**Flood Control Project Maintenance
Levee Inspections**
LMA District Cover Sheet
Spring 2019 Levee Inspection Results

Reclamation District No. 2058 Pescadero

Levee Inspection Report By Mile - Spring 2019

Waterway	Bank	Unit Miles	Inspection Start/End	Inspector
Unit No. 01 Paradise Cut	Left	6.58	05/06/2019 05/06/2019	Alberto De Leon

Photo 2 of 3 : UCIP_SP_2019_51699_45191.jpg

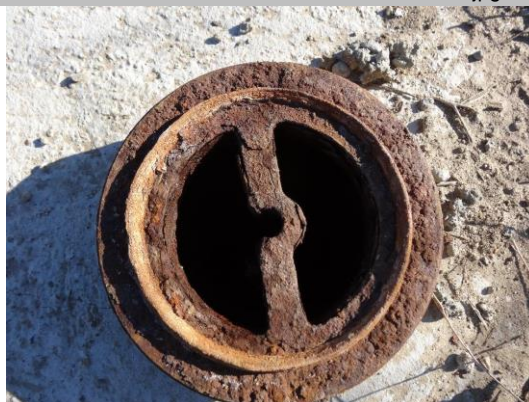
LM Start	2.12	Rating **	M	Issue No.	980 (cont)	
LM End	2.12	Issue Type +	Ma	Location *		
Category	Supplemental			GPS Latitude/Longitude		
				Start		End
Item	DWR UCIP LMA Responsibility			37.803886 °	37.803886 °	
				-121.386271 °	-121.386271 °	
DWR ID	22706					
Comment Code						
Inspector Comment						
FS_ID:51699						
DS_ID:22706						
EP_NO: N/A						
Repair Type: Non-Urgent						
Crossing Status: Found						
UCIP Comments: Leaky and damaged siphon breaker on waterside shoulder..						
FIELD_STRUCT_DESC: 16-inch steel drainage discharge pipe through the levee, 8 feet below the crown. Pump on a concrete sump in a drainage ditch on the landside (LS) toe. Siphon breaker on the waterside (WS) shoulder. [Additional Reference(s): USACE San Joaquin O&M Manual 10, March 1964, (HLM 2.14), 12-inch pipe referenced].						
FS Date: 5/13/2015

WS view: siphon breaker on concrete pad on levee slope.
